TITLE: SCHEMATIC/LOGIC DIAGRAM
 QUAD MONOCHROME CLUSTER PC'S

ENGINEERING CHANGE ORDER

ECO NO. 0012

DOCUMENT TITLE:
SCHEMATIC / LOGIC DIAGRAM
CPS-16QSDOCUMENT NO.:
7000401REVISION FROM: TO: SIZE
- | A. | B

Sheet 16: WAS
Zone C2

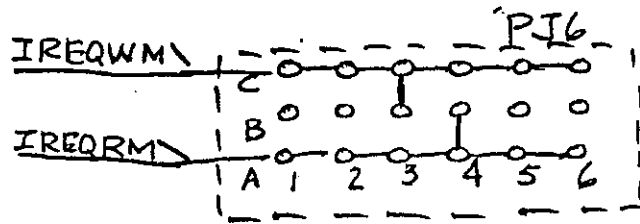
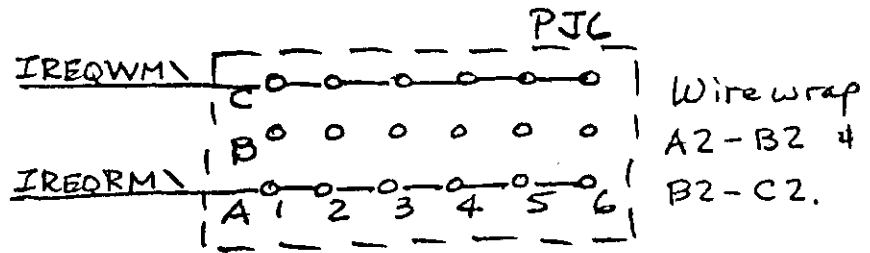
IS

Sheet 16: WAS
Zone A2

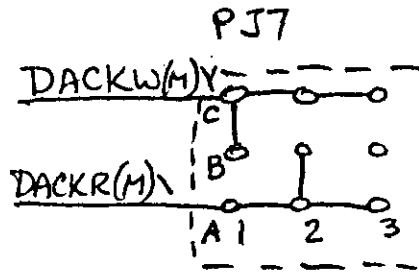
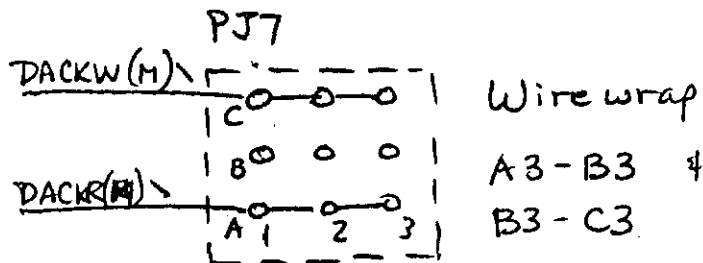
IS

Sheet 16: WAS
Zone B2.IS:

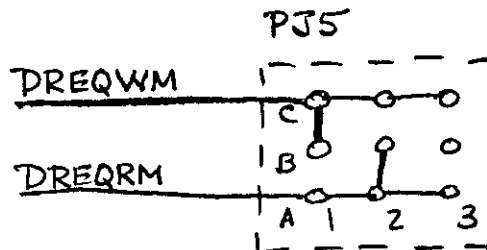
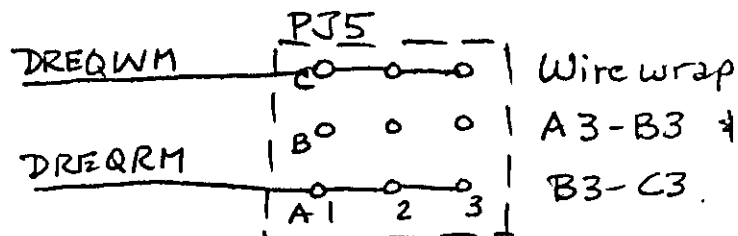
EXPLANATION:
To comply with most commonly used configuration.

CHANGE DESCRIPTION:
